**Agenda Item 1
February 5, 2018**

SUBJECT: Approval of the request of Pulte Homes of Michigan, LLC, for Emerson Park, JSP 17-10, with Zoning Map Amendment 18.717, to rezone property in Section 22, located on the west side of Novi Road between Ten Mile Road and Grand River Avenue from OS-1, (Office Service) to RM-2 (High Density Multiple Family Residential) subject to the related Planned Rezoning Overlay (PRO) Agreement, and corresponding PRO Concept Plan. The property totals approximately 24 acres and the applicant is proposing a 120-unit multiple-family attached condominium development.

Planning Review

Rezoning Request from OS-1 (Office Service) to RM-2 (High Density Multi-Family Residential) with a Planned Rezoning Overlay (PRO): **Revision 3**

sheet no:
LS-2 of 6

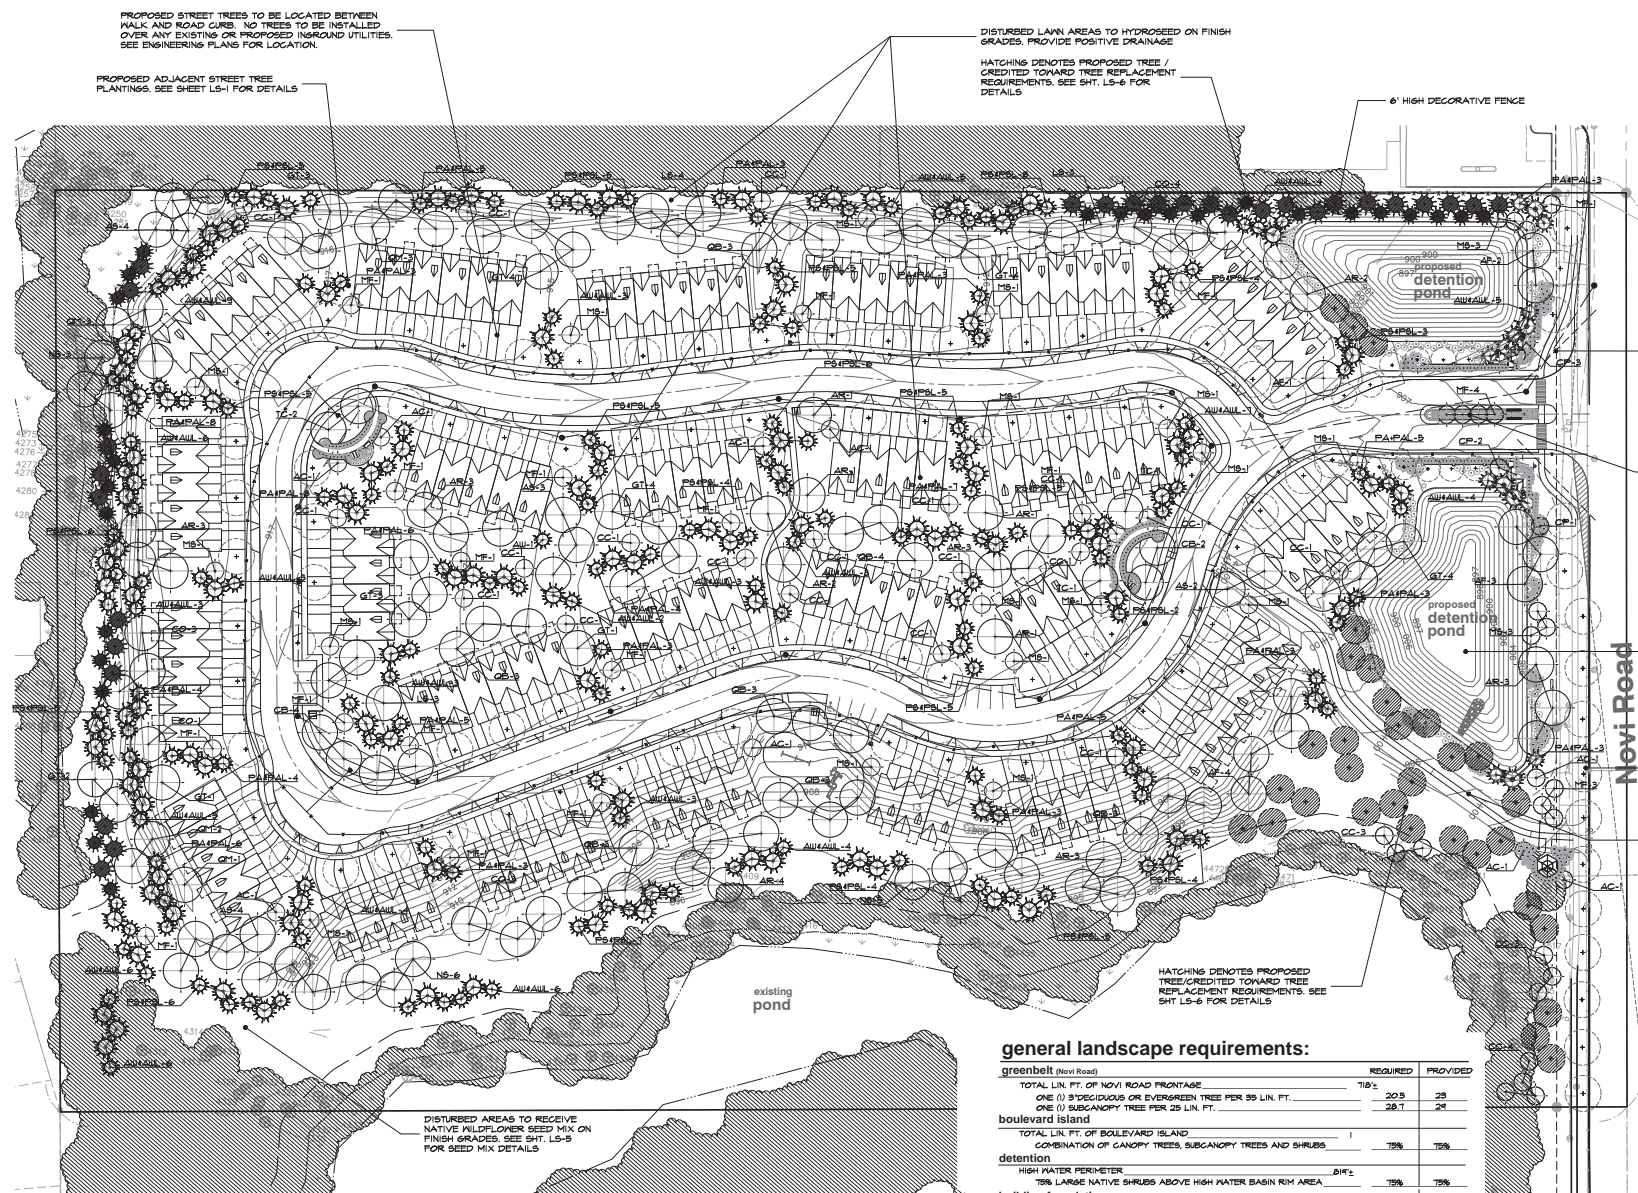
4. There is a contradiction between the two figures used as a basis for the street trees calculations. 3349 lf is shown as the basis, but the calculations show the number to be 2821 lf. The latter figure was used for the tree requirement. **Please use the correct number as the basis and remove the incorrect figure from the calculations. If the correct figure is 2,080 lf, then more than the required number of street trees is provided.**

Figure 1. City of Novi Regulated Wetland & Woodland Map (approximate project area is highlighted in red). Regulated Woodland areas are shown in green and regulated Wetland areas are shown in blue).

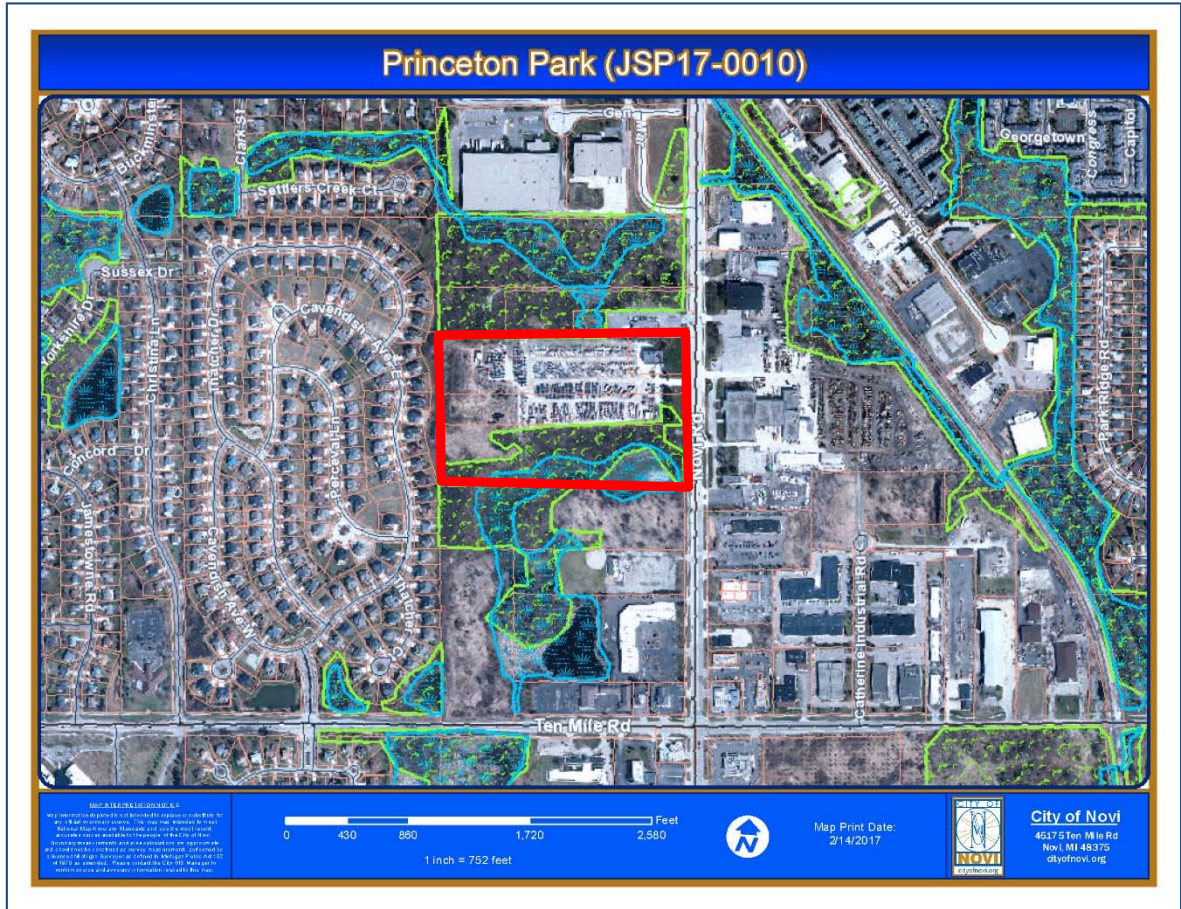
Based on our review of the Plan, Novi aerial photos, Novi GIS, the City of Novi Official Wetlands and Woodlands Maps (see Figure 1, attached) it appears as if this proposed project site contains City-regulated wetlands and woodlands. The City's wetland and woodland map shows that the overall property contains wetlands to the south. However, a review of aerial photos of the site and the proposed site plan, the site contains three (3) areas of wetland (Wetlands #1, #2, and #3), along both the southern and western portion of the site.

ECT completed an on-site woodland evaluation on Tuesday, February 21, 2017. As noted above, the site does contain area designated as City of Novi Regulated Woodland. A significant portion of the proposed limits of disturbance for the project is located outside of the areas mapped as City Regulated woodland (see Figure 1). The

majority of the Regulated Woodland area is located on the southern portion of the project site (see Figure 1). Tree survey information has been provided on the *Tree List* plan (Sheet 03). This sheet includes a tree list that indicates the proposed woodland impacts and required Woodland Replacement tree credits for these removals. The Plan indicates that a total of 328 trees have been surveyed for the project. Of the trees surveyed, 262 trees are located within the area designated as Regulated Woodland (80% of the surveyed trees are located within the regulated woodland area). Fifty percent (50%) of the surveyed trees are comprised of the following tree species:
